# Combroke Parish Council

## Consultation for Planning Application 16/03397/FUL

### Proposal: relocation of vehicular access and associated landscaping

at: No 14, Combrook, CV35 9HP

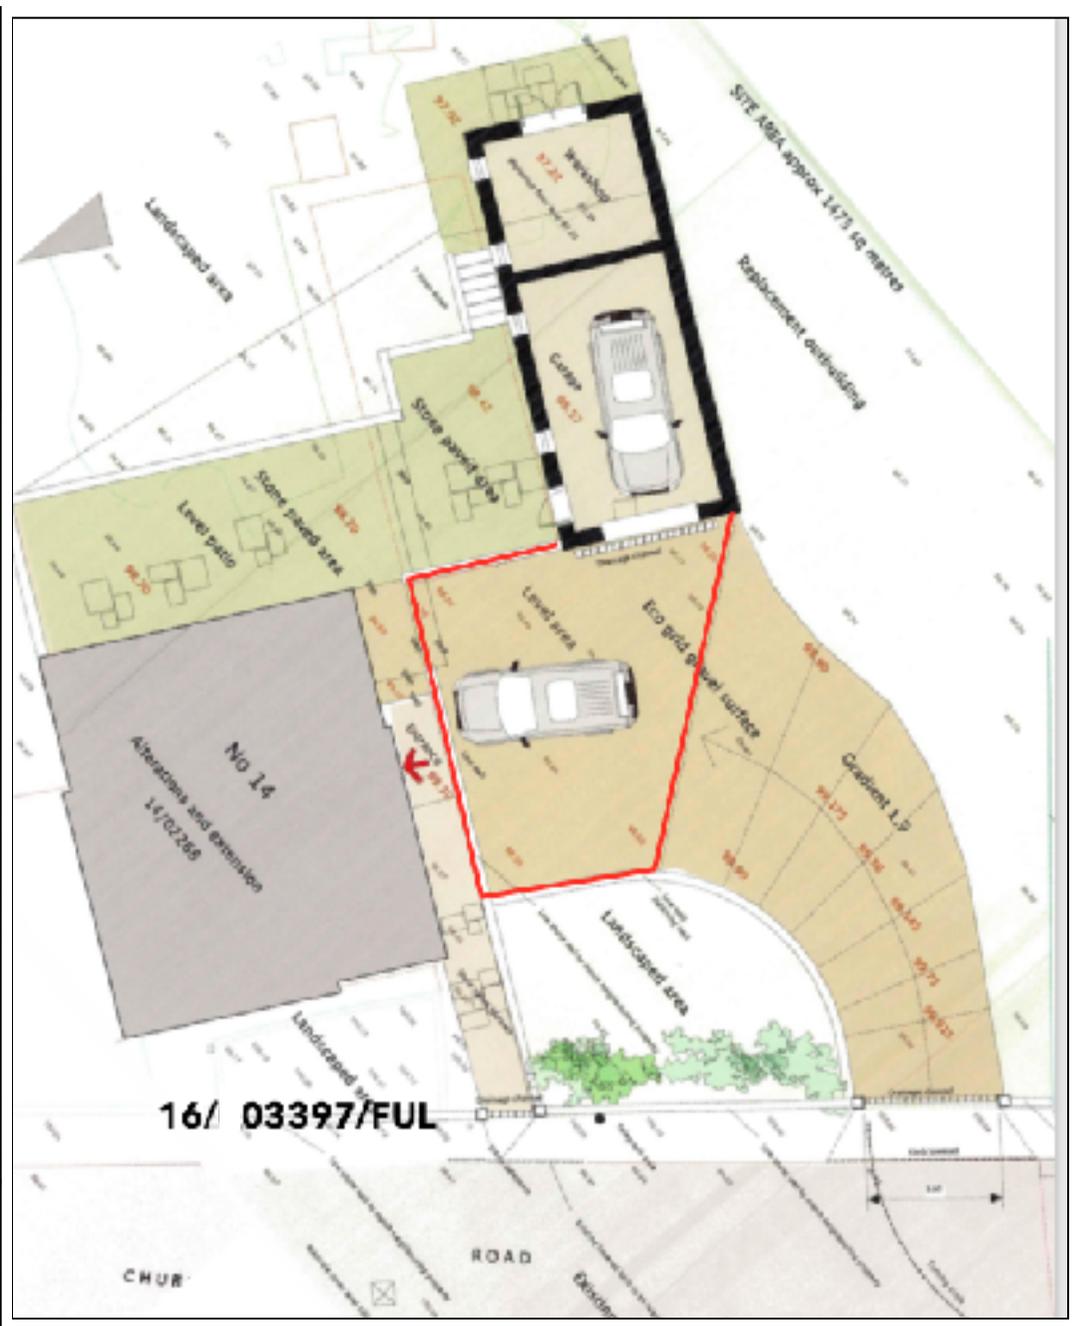
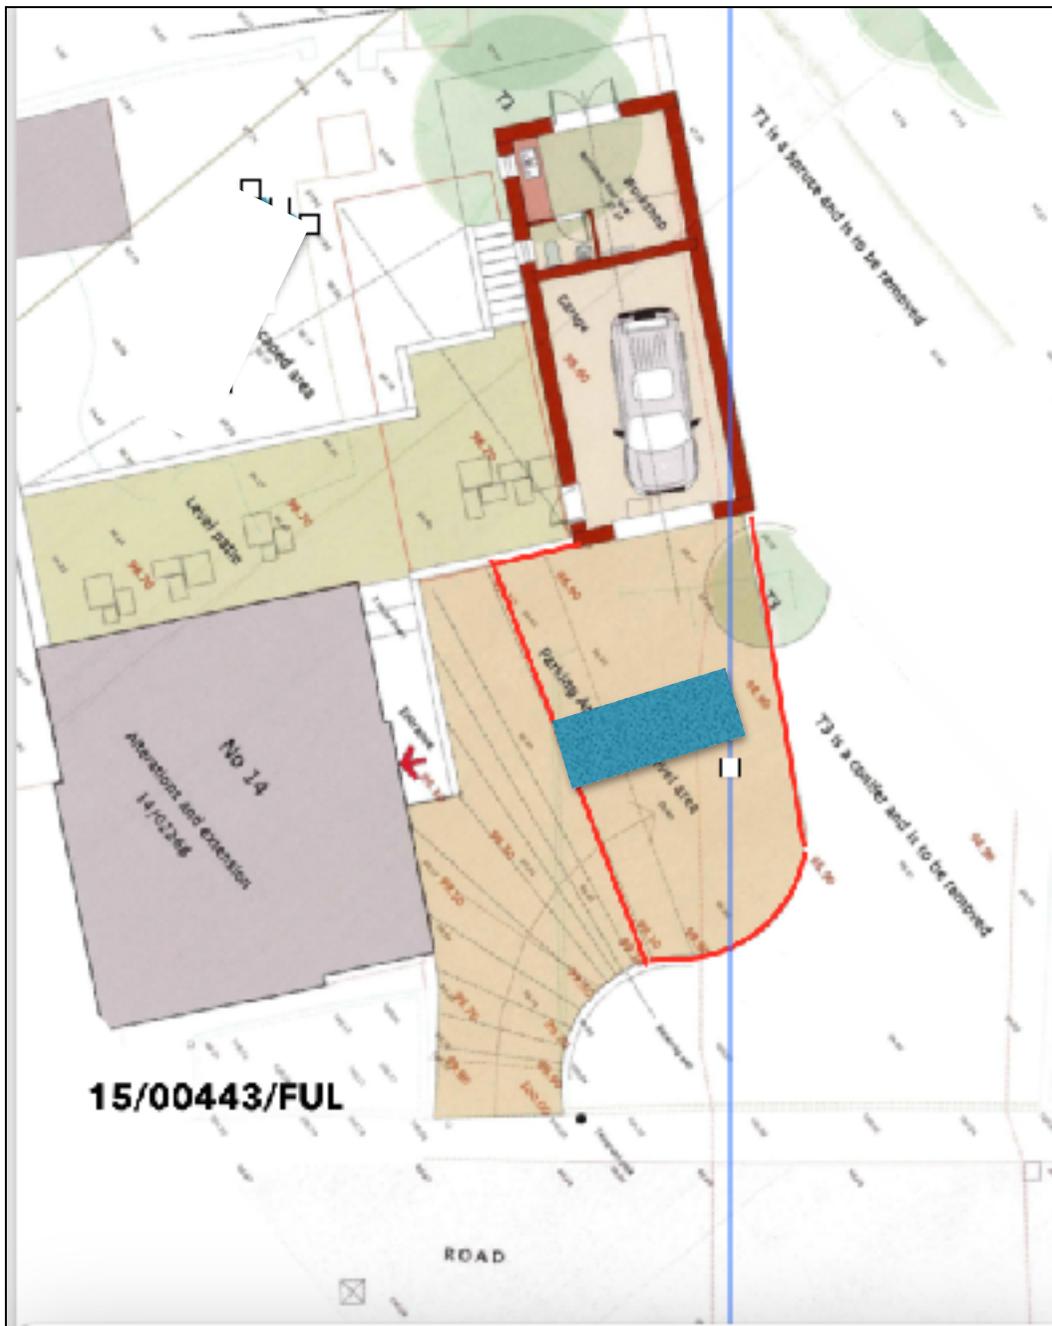
- 2.6. There are significant inconsistencies between the approved plan and the proposed plan. The approved plan 15/00443/FUL shows the garage floor level and the level parking area both at 98.90m, 14/02268/FUL also shows the same level. This proposed plan indicates a **400mm difference**. The plan indicates the level parking area will be 98.50m,

i.e 400mm lower which is a significant difference, and it shows a garage floor level at 98.57m. It is noted that the entrance to the main dwelling remains at 99.30m. If Officers are minded to approve this application, **clarification is required about these data before the application is determined.**

- 4.6. Building for Life 12 (p 11) reinforces the view that vehicle domination should be avoided. This proposed scheme for access/parking, as an alternative to that approved in 15/00443FUL completely engulfs the full width of this side garden land. It is an unnecessary and damaging amendment with very little difference in the "parking area" achieved. Refer to Fig 1 attached.

- 4.7. The plan describe the retaining walls as "low wall", as proposed for the boundary. The given levels on the plan indicate otherwise, the data given indicate a drop of 1.5m from the lane to the "level parking area". This five foot drop will require very significant landscaping and retaining walls will be much higher than the "low wall" suggested. This will substantially change the character of this plot in relation to both the listed buildings and this prominent location in the village. In place of a grassy slope is a piece of extensive hard landscaping more commonly found in urban areas.
